# **Intel® Mobile Pentium® III Processor Specification Update**

Release Date: June 2000

Order Number: 245306-008

Figure 7. BCLK Timing Waveform

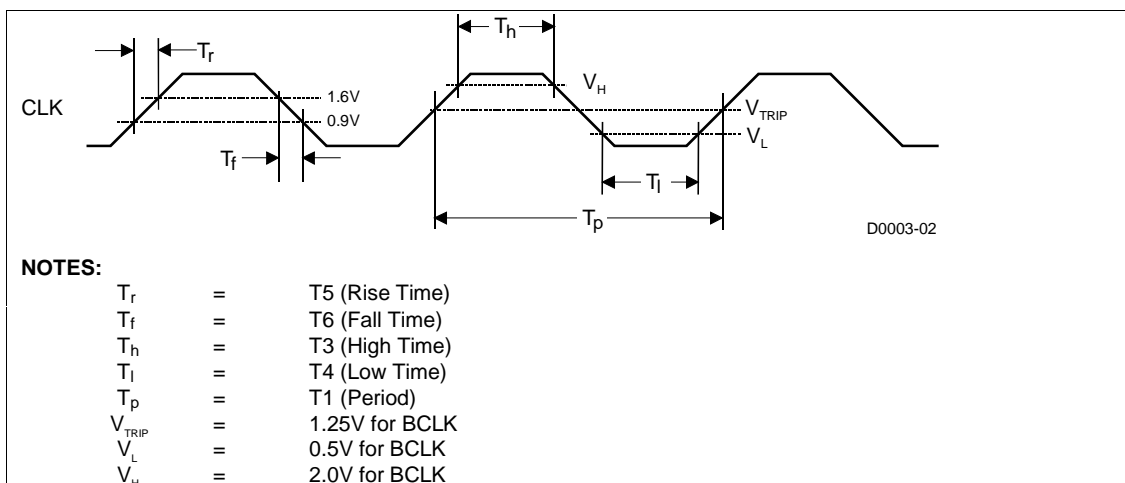
For B0 step processors, the  $V_{IH,BCLK}$  Min spec is changed to 2.0V (from 1.7V for A2 step) and  $V_{IL,BCLK}$  Max spec is changed to 0.5V (from 0.7V for A2 step). Due to this, new values are specified for BCLK high and low times for B0 step processors. These modifications affect corresponding specs in Table 13, Table 14, Table 24, and Figure 7 in *Mobile Pentium® III Processor in BGA2 and Micro-PGA2 Packages datasheet* (Order Number 245302-002).

The following tables and figures highlight the above mentioned BSEL[1:0] and BCLK specs modifications made for B0 step processors:

Symbol	Parameter	Min	Typ	Max	Unit	Figure	Notes
	System Bus Frequency		100		MHz		
T1	BCLK Period		10		ns	Figure 7	Note 2
T2	BCLK Period Stability			$\pm 250$	ps		Notes 3, 4
T3	BCLK High Time	2.70			ns	Figure 7	at >2.0V
T4	BCLK Low Time	2.45			ns	Figure 7	at <0.5V
T5	BCLK Rise Time	0.175		0.875	ns	Figure 7	(0.9V – 1.6V)
T6	BCLK Fall Time	0.175		0.875	ns	Figure 7	(1.6V – 0.9V)

Figure 4. BCLK Waveform at the Processor Core Pins

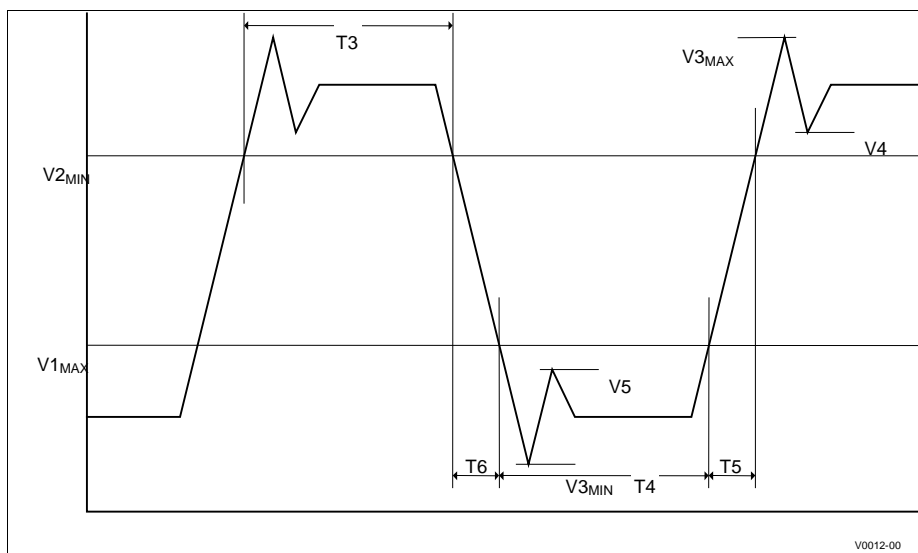
In Table 18, “BCLK Signal Quality AC Specifications at the Processor Core” of the *Intel® Pentium® III Processor Mobile Module: Mobile Module Connector 2 (MMC-2)* datasheet, and Table 19 of the *Intel® Pentium® III Processor Mobile Module: Mobile Module Connector 2 (MMC-2) Featuring Intel® SpeedStep™ Technology* datasheet, Note 3 has been updated. Figure 4 “BCLK Waveform at the Processor Core Pins” has also been updated. See below.

- The rising edge ringback voltage specified is the minimum absolute voltage that the BCLK signal can dip back to after the BCLK signal passes the  $V_{IH,BCLK,MIN}$  (rising) voltage limits. The falling edge ringback voltage specified is the maximum absolute voltage that the BCLK signal can dip back to after the BCLK signal passes the  $V_{IL,BCLK,MAX}$  (falling) voltage limits.
